**PUBLIC UTILITIES COMMISSION**

GI-2023-08-PGE-29-20

**SUBJECT:** Closure letter for General Order (G.O.) 112-F Compliance Audit of Pacific Gas and Electric's Pipeline Construction and Material Traceability.

Figure 1. Station Project S-1137 As-built Drawing

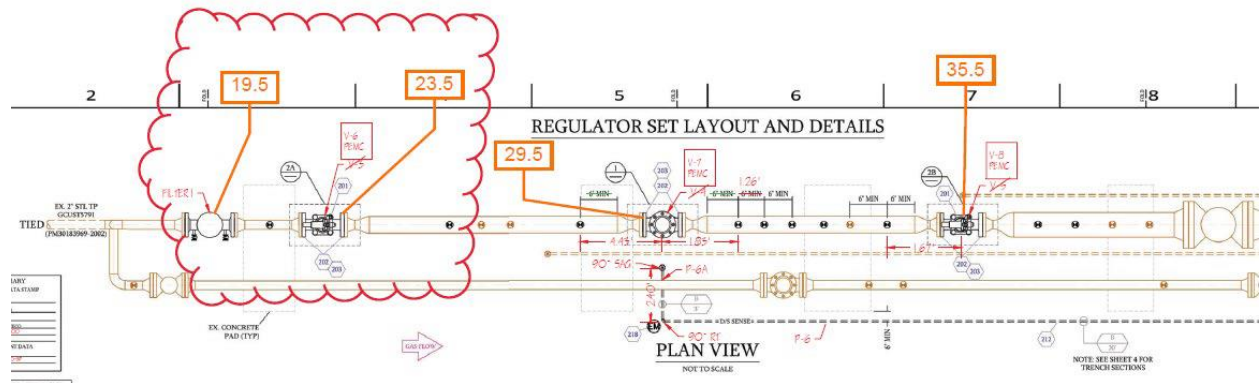
Review of PG&E’s construction documentation for project S-1137, revealed that the 2-inch regulators (2” X 1” Mooney Flow Grid) V-6 and V-8 noted on the as-built drawing were not in the Component Receiving Log or Valve Receiving Log that PG&E provided to SED during the audit. SED requested PG&E to provide the receiving log for those regulators, but PG&E was unable to provide a Component Receiving Log that showed the regulator valves V-6 and V-8. PG&E’s representative explained that the regulator valves were not included in the PG&E’s Material Traceability Scope log because components that are 2 inches or less were not required to be documented. PG&E argued that its material traceability scope outlined in Standard TD-4030S, covered only components greater than 2 inches with yield strength grades of 42’000 psi or greater. Also, PG&E argued that it did not classify the regulators as valves, hence, PG&E does not have to record the regulators in the component receiving log. However, the Standard TD-4030S required material traceability record for valves of all diameters, and the specification sheet from the manufacturer of the 2” X 1” Mooney Flow-Grid regulator describe it as a “Pilot Operated Valve”. The As Built Drawing did not match the Bill of Material (BOM).

SED consulted PHMSA’s subject matter expert regarding this issue, whether a Pilot Operated Regulator is a Valve and falls under the Valve category for material traceability. PHMSA’s response was “Yes, the 2” x 1” Mooney Flow Grid regulator is used to control flow and pressure and hence it is a valve.”

PHMSA indicated that the Mooney Flow Grid regulator is a valve. Therefore, PG&E is in probable violation of G.O. 112-F Reference Title 49 CFR, Part 192 Section 192.205(a). .

If the Mooney Flow Grid regulator is considered a valve for the purposes of material traceability, the documentation required by 192.205(a) is provided on the Drawing, Bill of Materials (BOM), and Gas Design Standard (GDS), all of which have correlation through the Item number and Material Code. The 2” x 1” Mooney Flow Grid regulator in question is indicated below as Item #201 on the Drawing (Figure 1), which correlates to Item #201 on the BOM (Figure 2). Additionally, GDS H-80 (Figure 3) specifies the standard and pressure rating.

Part 192 Section 192.205(a) does not have a definition of a valve or a fitting. SED reviewed API Specification 6D requirements for the design, manufacturing, assembly, testing, and documentation of ball, check, gate, and plug valves. However, "Pilot operated valve" was not included in the API Specification 6D. Also, SED reviewed ASME B31.8, "Gas Transmission and Distribution Piping Systems – ASME Code for Pressure Piping" Sections 803.6 and 803.7 that define different types of regulators and valves. SED will consult with PHMSA. At the meantime, SED will close this 2023 G.O. 112-F audit of PG&E's Pipeline Construction and Material Traceability compliance.

Figure 5. R-445, As-built drawing

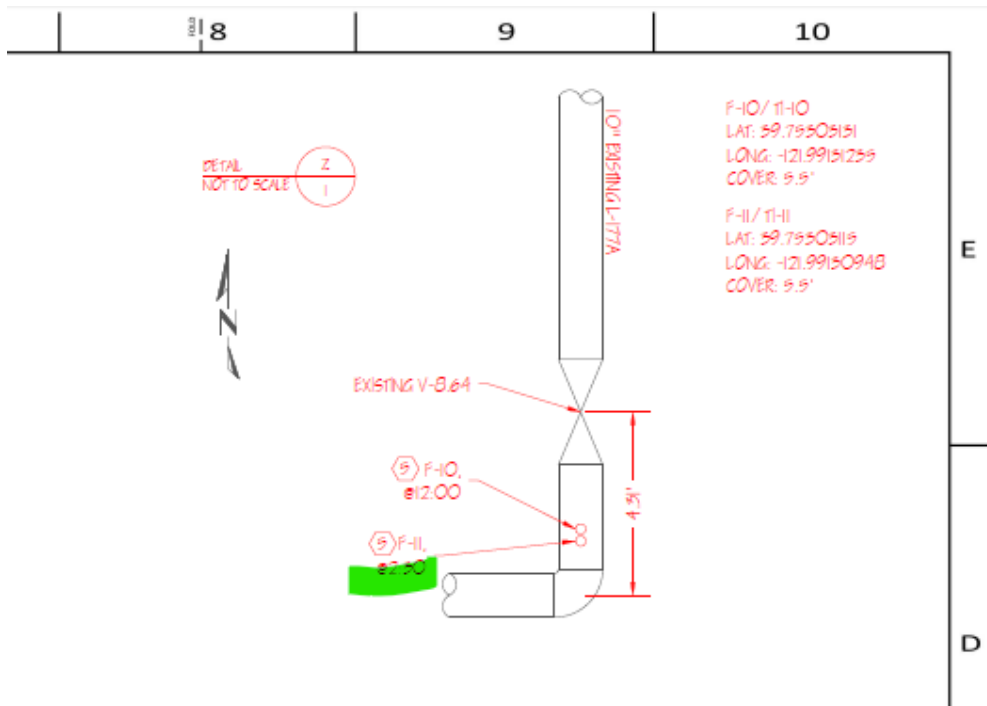
4). In Project –R445, the description of the save-a-valve F11 on the weld map indicated the F11 location to be @ 2:30. However, the as-built drawing description showed that the location of F11 was @10:30.

SED recommends PG&E verify the location of the save-a-valve F11 and make the final tie-in weld map description consistent with the as-built drawing.

PG&E disagrees with this finding. Both the as-built drawing (Figure 5) and weld map (Figure 6) indicate save-a-valve F-11 to be at the 2:30 position.

SED accepts PG&E's response. However, SED may verify the as-built drawing during future audits.

Figure 7. R-445 as-built, Pipe Section P-55

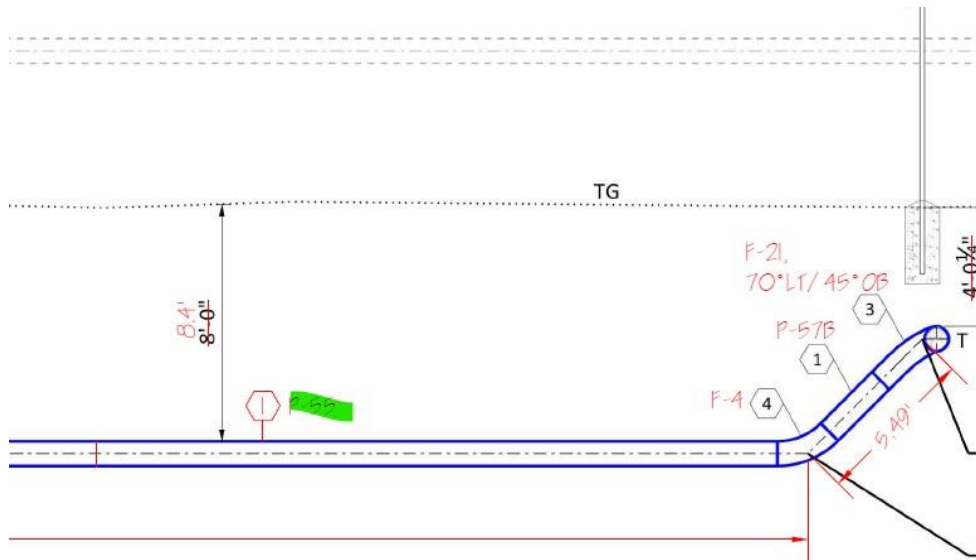
- Description of the location of the Save-a-valve F-25 was documented as 0.5 feet from TW-122, whereas it should have been TW-121.
- The save-a-valve installed on pipe P-111A was recorded as F- with no assigned component number.
- Pipe component P-100B was used twice in hydrotest weld map (26.52' at STA 0+46.54 and 1.00' at STA 47+29.08). There was another section of 5.54 feet pipe labelled P-100 instead of P-100E that was used for the hydrotest tie-in bullet. In SED's DR#24, PG&E clarified that the 26.52 feet of P-100B should be P-100D. P-100 was cut out and used for fit-up at the tie-in location and became P-100C. The P-100A, P-100B, and P-100D were cut out after the hydrotest and scrapped and were not put into service.
- Pipe sections labelled P-55 (28.17' at STA 46+12.28) and P-55B (12.73' P-55B at STA 47+16.39) were used instead of P-55A and P-55B.

The Weld map was completed on 10/17/2019. PG&E did not have guidelines for labeling of pipe components prior to the material labeling standard in TD-4030P-03, that went into effect on 10/19/2019. Although those pipe sections/components were not permanently installed on the pipe, SED recommends that PG&E document accurately the component number and description of the pipe segments/sections.

- d. PG&E disagrees with this finding. Both the as-built drawing (Figure 7) and hydrotest weld map (Figure 8) depict P-55.

SED accepts PG&E's response. SED may verify the weld maps during future audits.
